**PROJECT: Multi-Sport Venue in Eastern New Orleans and Lower Ninth Ward
4290 Almonaster Avenue,
New Orleans, LA 70126**

ADDENDUM NO. 2

OPSB Project No. ITB 26-FAC-0053

January 23, 2026

**Concourse Level -
Sector A - North
Buildings, Field, &
Grandstands**
A101.3A
100% CONSTRUCTION
SET

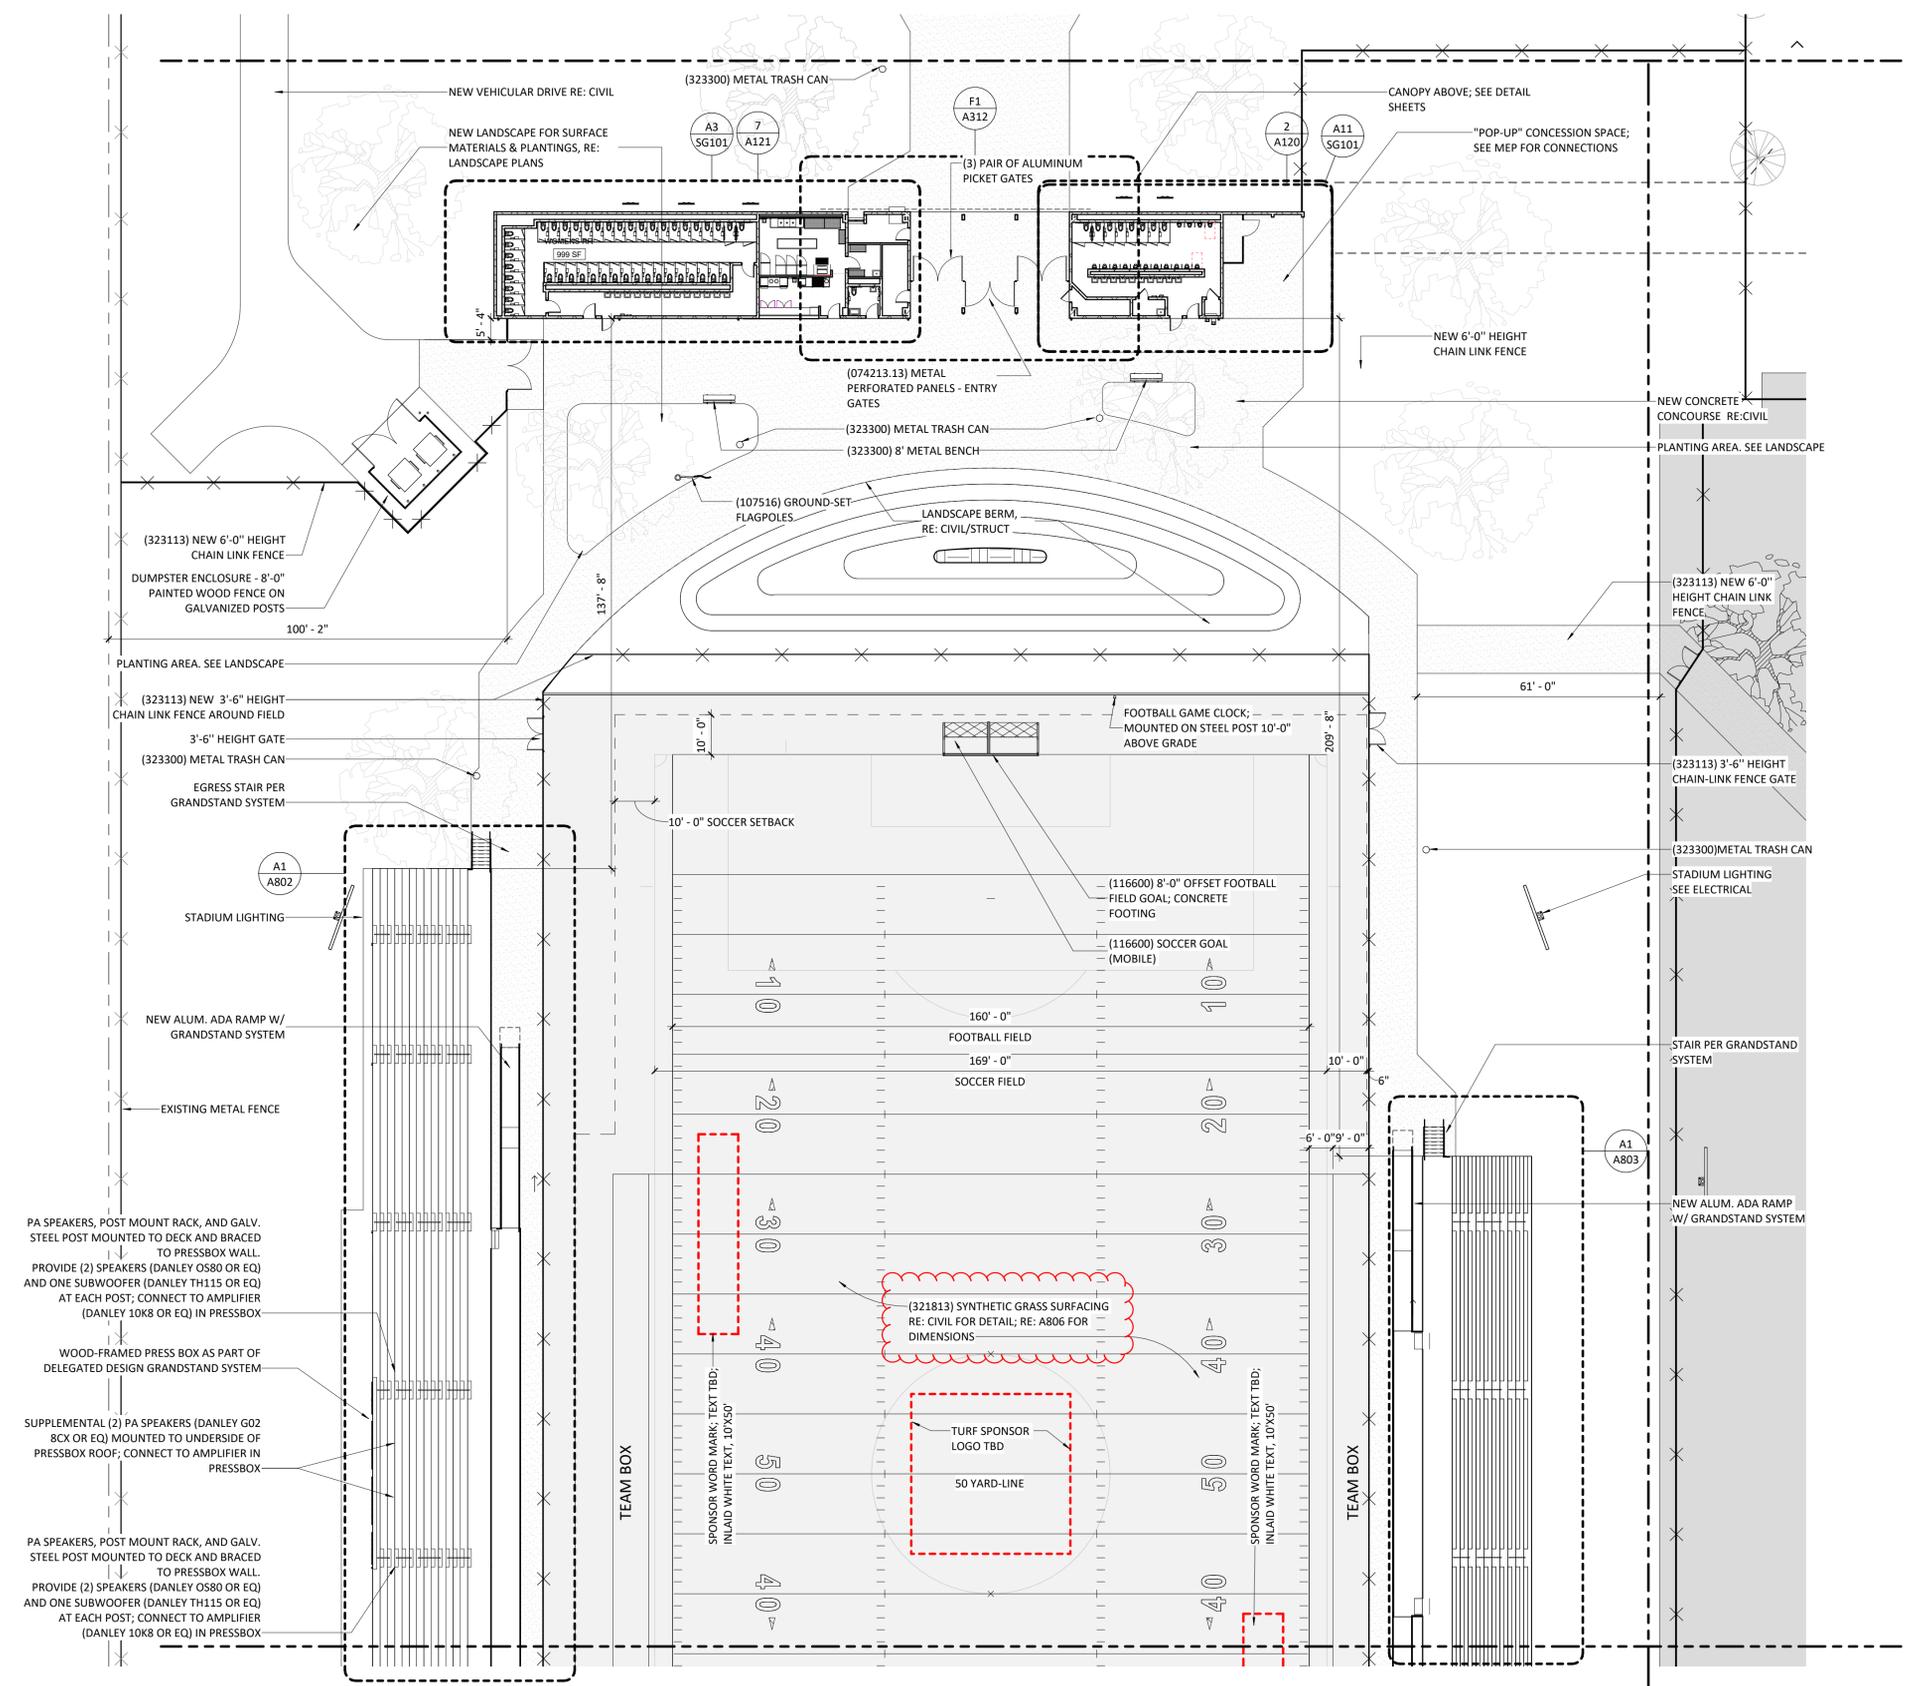
Response: The AISC certification is required and to remain for this project.
11. On A101.4B, the note in the middle of the field that mentions the "Synthetic Grass Surfacing" calls for you to reference A130 for dimensions. A130 currently does not exist in the contract documents.

Response: The note on sheet A101.3A and A101.4B referencing sheet A130 has been replaced with sheet A806.
12. Regarding the synthetic turf, will you be asking for a groomer or sweeper to be furnished in the bid?

Womens RR, Concessions, Ticketing - Enlarged Plan 7
3/16" = 1'-0"

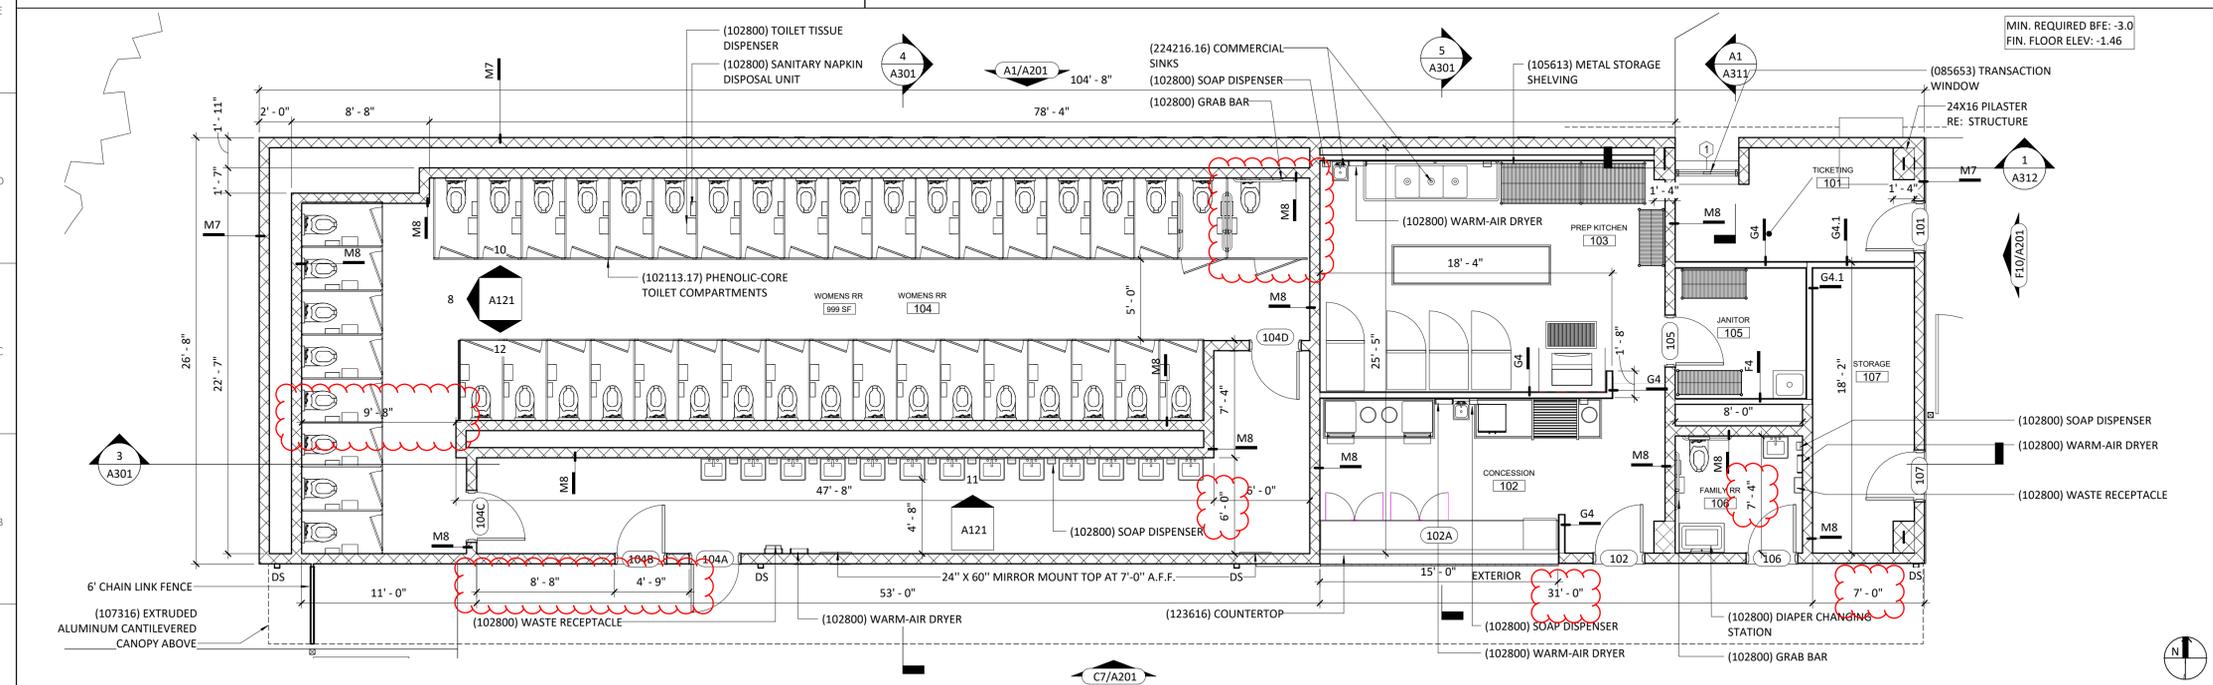
3. TreeTop Products is now Barco Products. The name has been updated in the following sections of 323300 – Site Furnishings - 2.1.A.3; 2.2.A.3; 2.3.A
4. Dimensions are updated on sheet A121, detail 7 - Women's RR, Concessions, Ticketing Enlarged Plan.

Entry Canopy Section A5

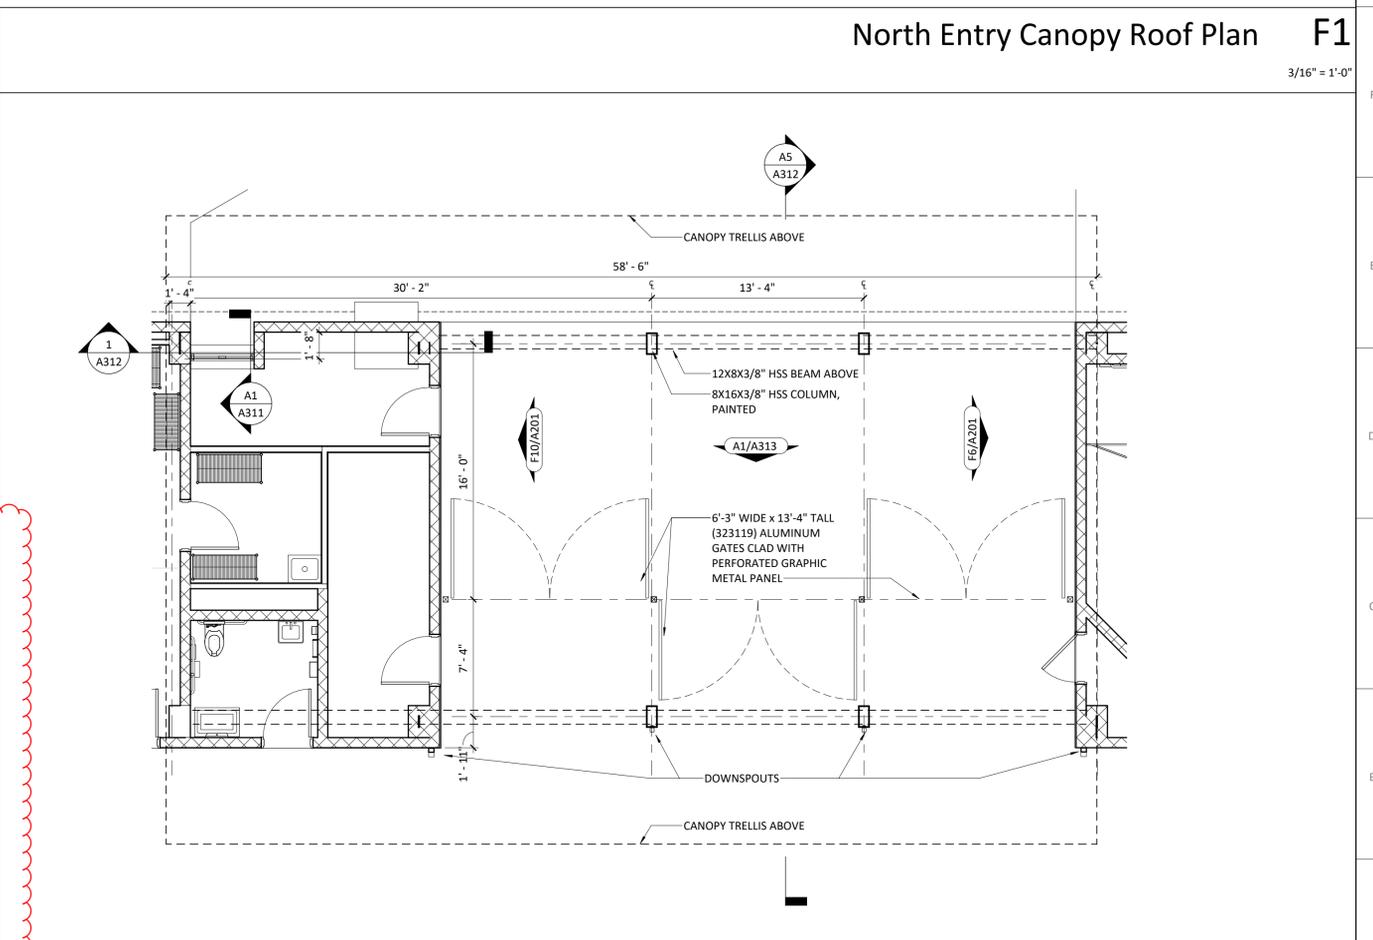
5. The height of the beams at the entry canopy have been noted on sheet A312, detail A5 – Entry canopy Section and sheet S109, detail 3 - Section.
6. The condensing units on the South Building east side are shown mounted to the wall on Sheet M401.

8 TYPICAL SECTION AT SPORTS FIELD

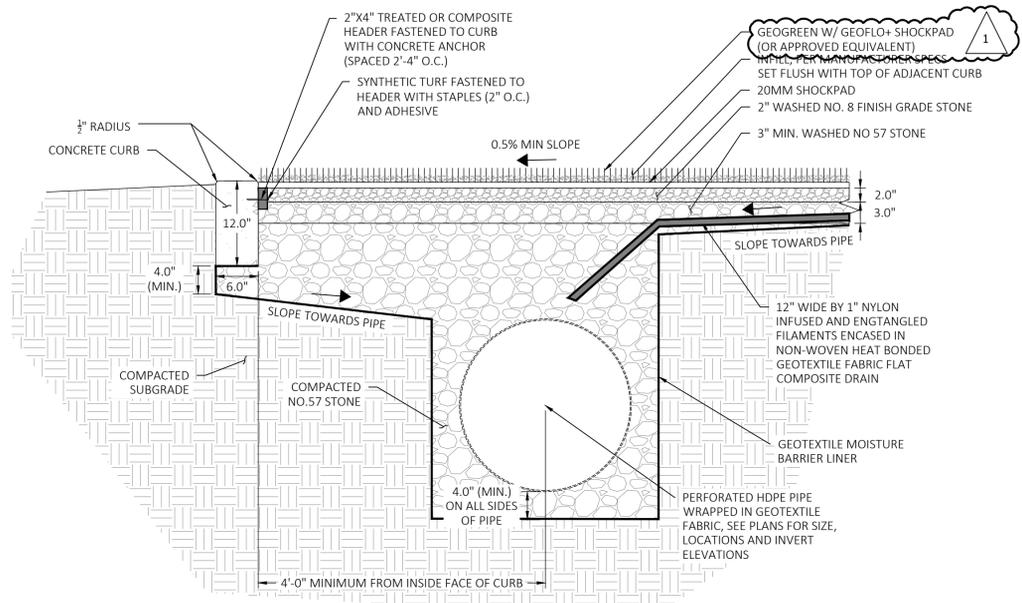
15. Site Plan Legend note 7 on C14 & C15 mentions that the turf is "Provided by Owner". Please advise if the turf is to be provided by the GC or Owner. That same note also references detail 8, sheet C28. Detail 8 does not exist. Please provide detail 8.

Response: Turf is included in the base scope. The note "provided by owner" has been replaced in note 7 on sheets C10 to C18. Note on sheet C7, detail 8 has been updated.

1 RAIN GARDEN PLANTING - 5 - 15 GAL.
L2.0|L2.12 1" = 1'-0" PLANTING DETAILS

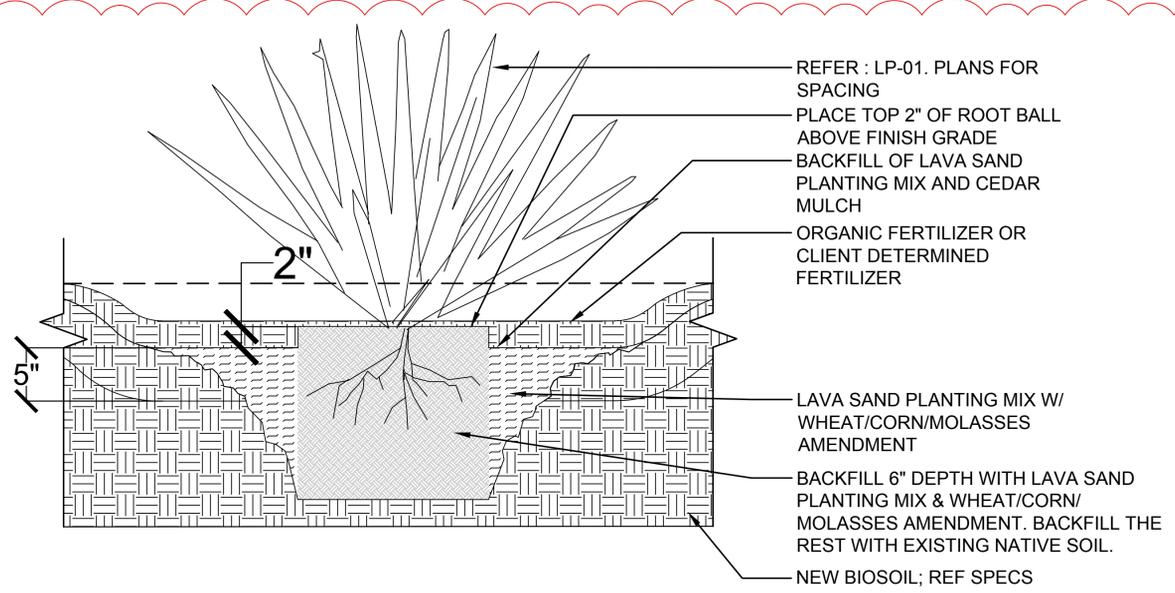
14. In details 1&2/L2.12 and 1/L2.14, it mentions new biosoil and to references L3.1. L3.1 was not included in the contract documents. Please provide this plan or the appropriate detail.

Response: Sheet L3.1 is not a part of the drawing set. The biosoil note in details 1&2/L2.12 and 2/L2.14 have been updated. Specification section 329113 - Soil Preparation; 2.3 - Rain Garden Soil Media has been added. Subsequent sections have been renumbered.

6 SECTION
S100 S200 1" = 1'-0"

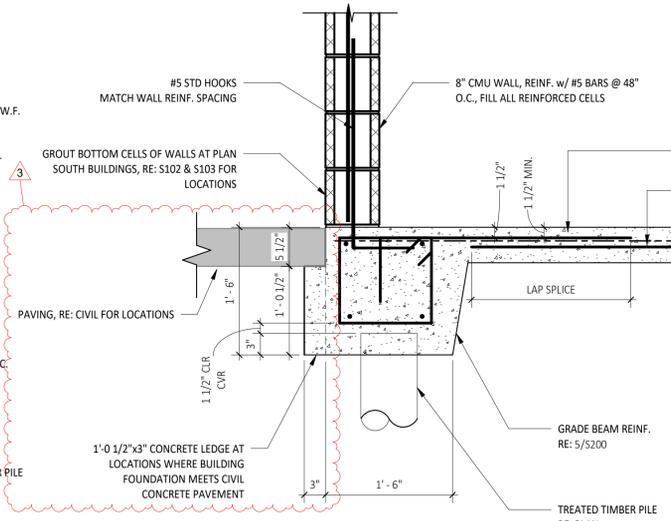
9. A concrete foundation ledge is provided in detail 6 on sheet S200.
